June 24, 2025

ADDENDUM NO. #1
City of Arnold, Missouri
Missouri State Road Shared-Use Path (TAP-9901 (692))

PLAN SHEETS
SHEET 3 OF 4

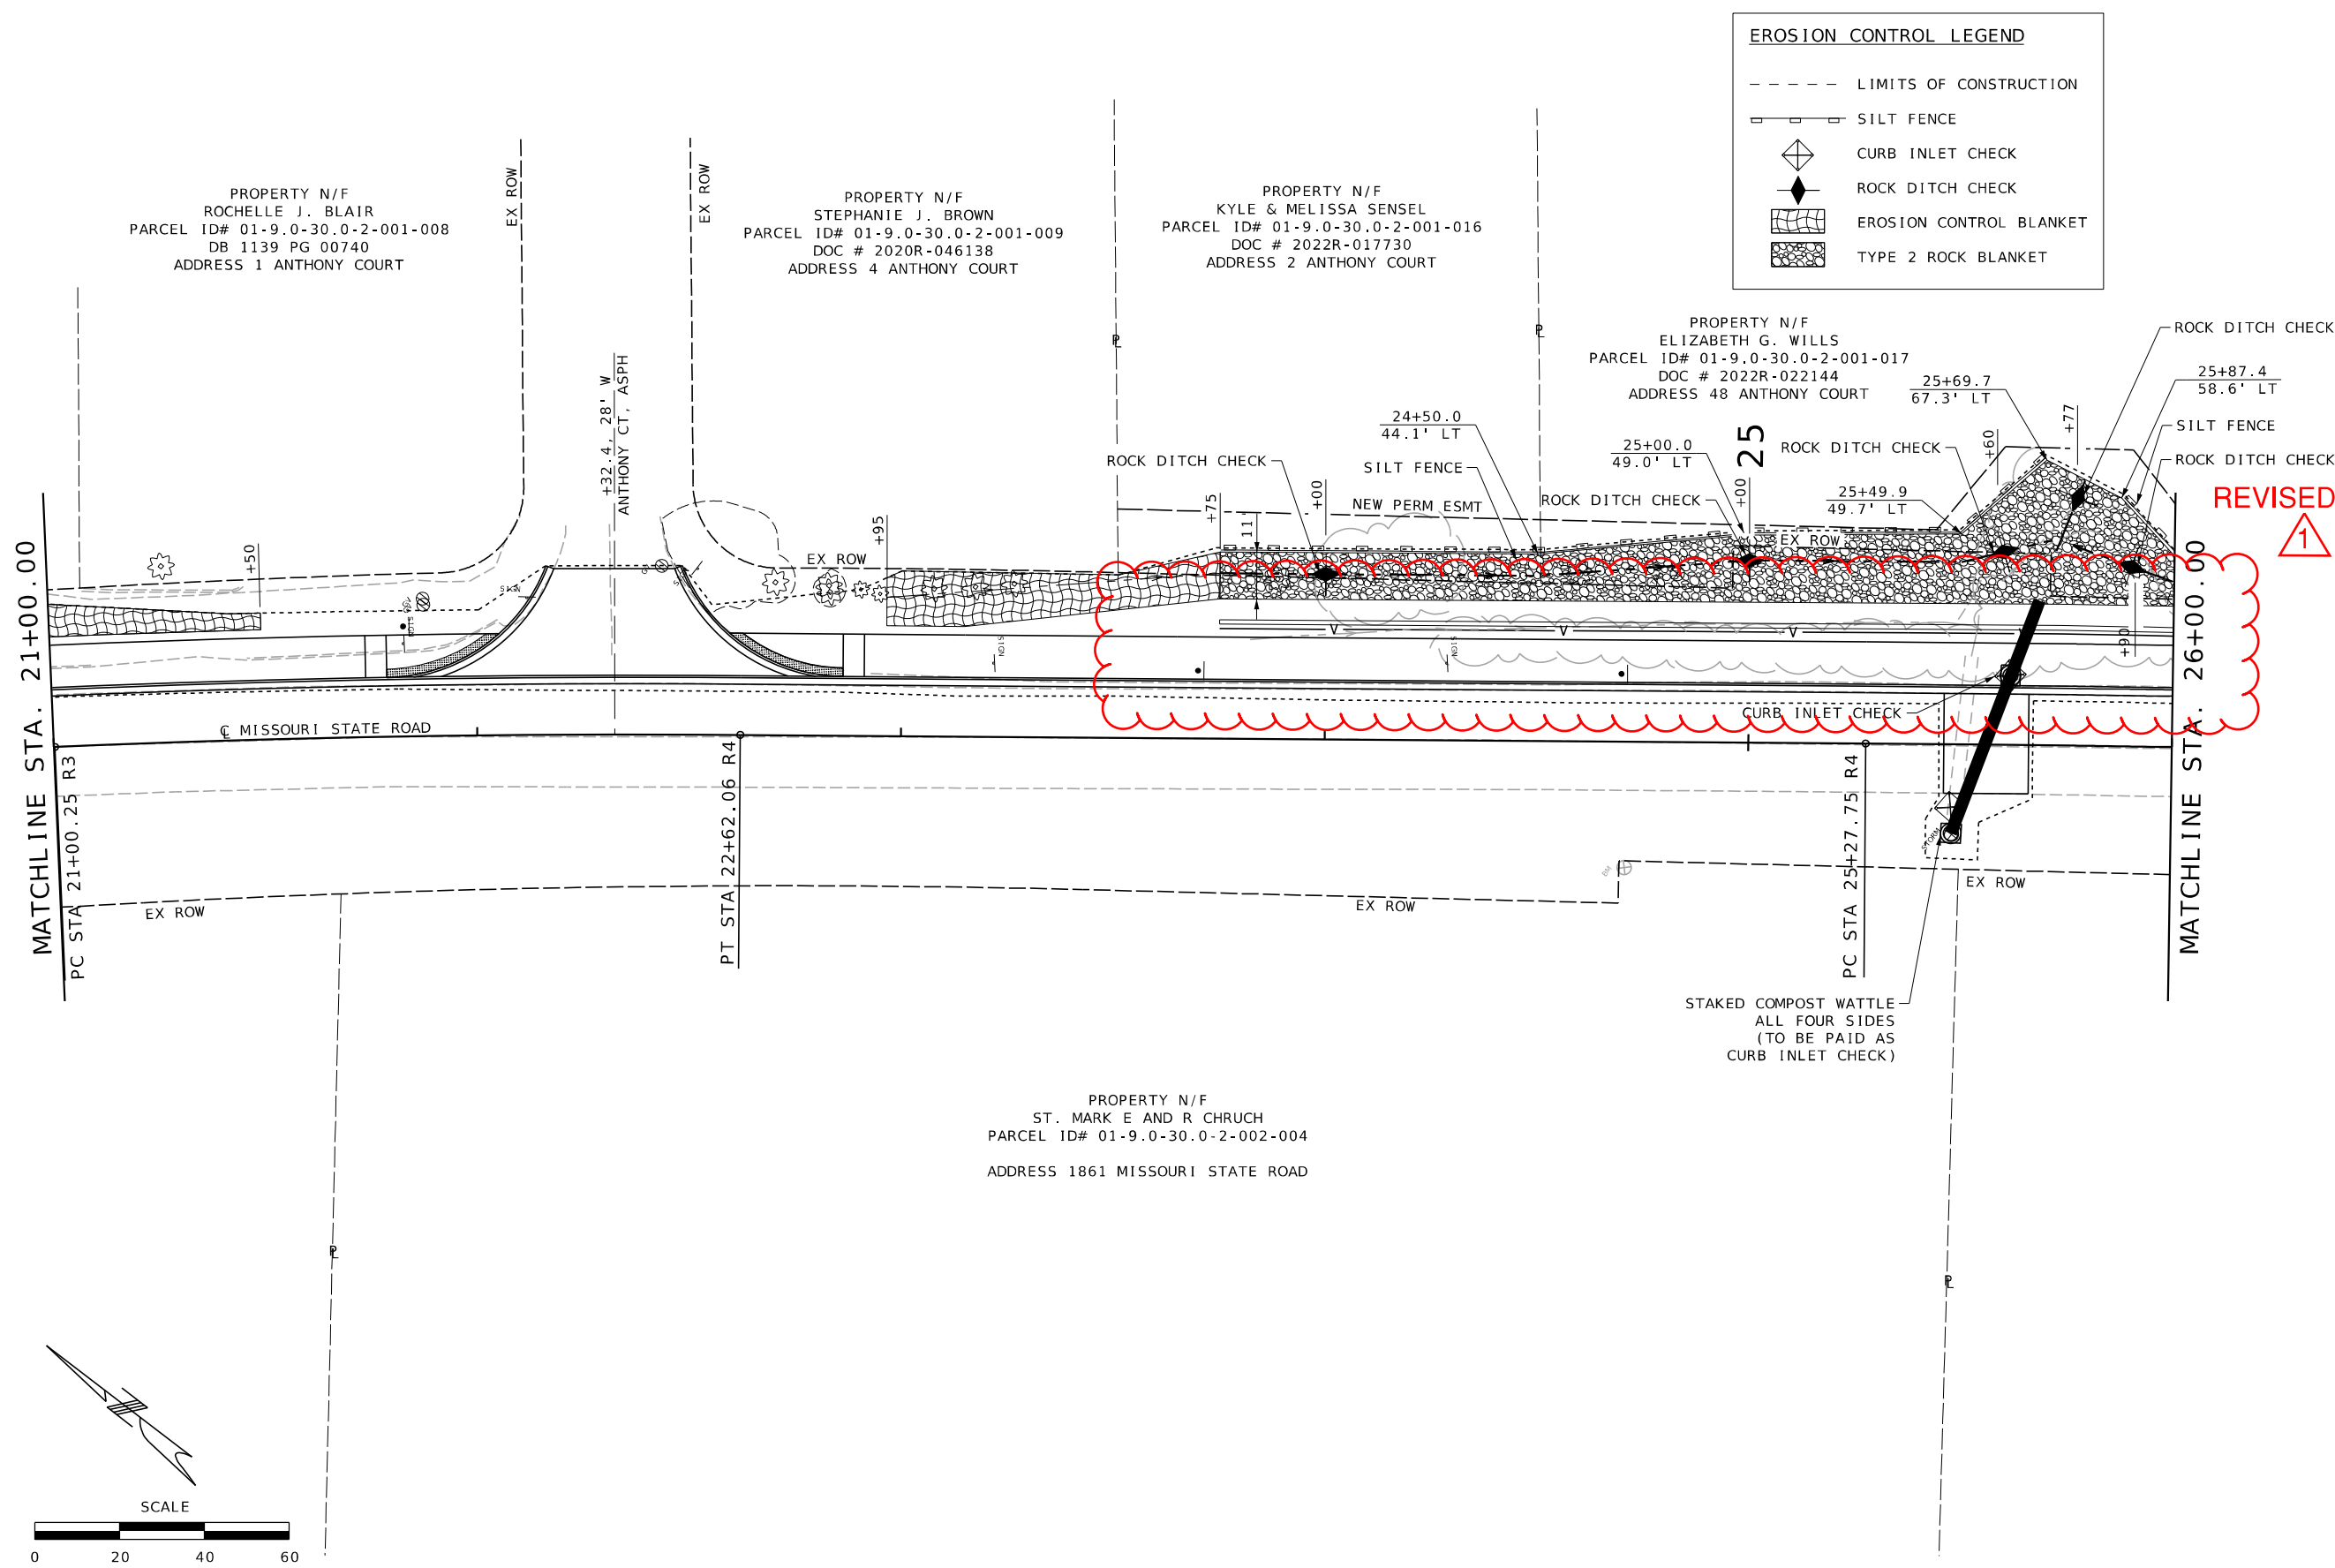
1. Summary of Quantities (Sheet 3 of 53) – Revised quantities
2. Typical Section Sheets (Sheet 6 of 53) – Revised proposed typical section between Sta. 23+15 to Sta. 26+65 to reflect new typical section.
3. Schedules (Sheet 7 of 53) – Revised Earthwork Schedule
4. Plan Sheets (Sheets 12-13 of 53) – Revised typical section between Sta. 23+15 to Sta. 26+65.
5. Erosion Control Sheets (Sheets 22-23 of 53) – Revised typical section between Sta. 23+15 to Sta. 26+65.
6. Right of Way Sheets (Sheets 26-27 of 53) – Revised typical section between Sta. 23+15 to Sta. 26+65.
7. Cross-Sections (Sheets 49-52 of 53) – Updated cross sections and estimated earthwork to reflect changes to the typical section.
